Indian comments on GRE 2017/12

A. Proposal

1. Replace figure in Annex 4 , Fig 2a

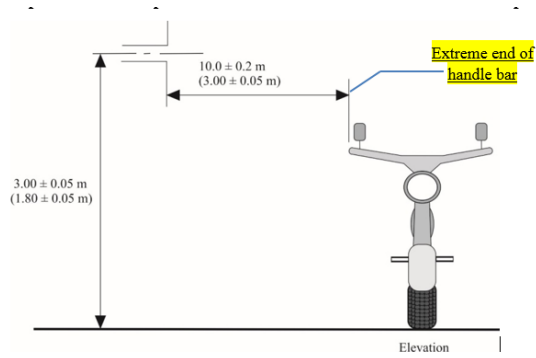
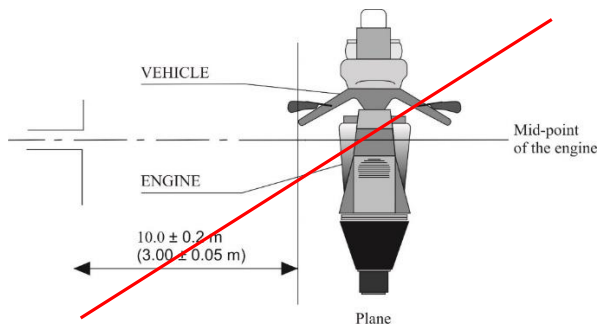
For Sr No 1&2 : To bring in more clarity & uniformity of measurement distance between Antenna & vehicle.

3. Replace figure in Annex 6 Appendix 1 Figure 2

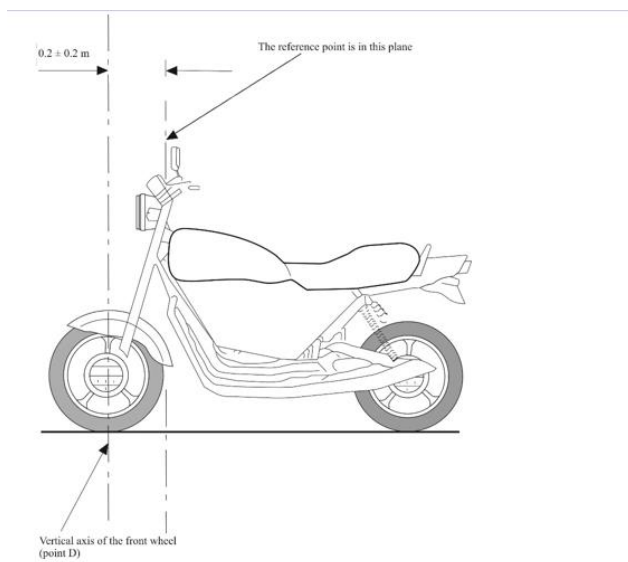
For Sr No3 : To align as per Annex 6 – Appendix 1 figure 1 “Three wheeled vehicle”
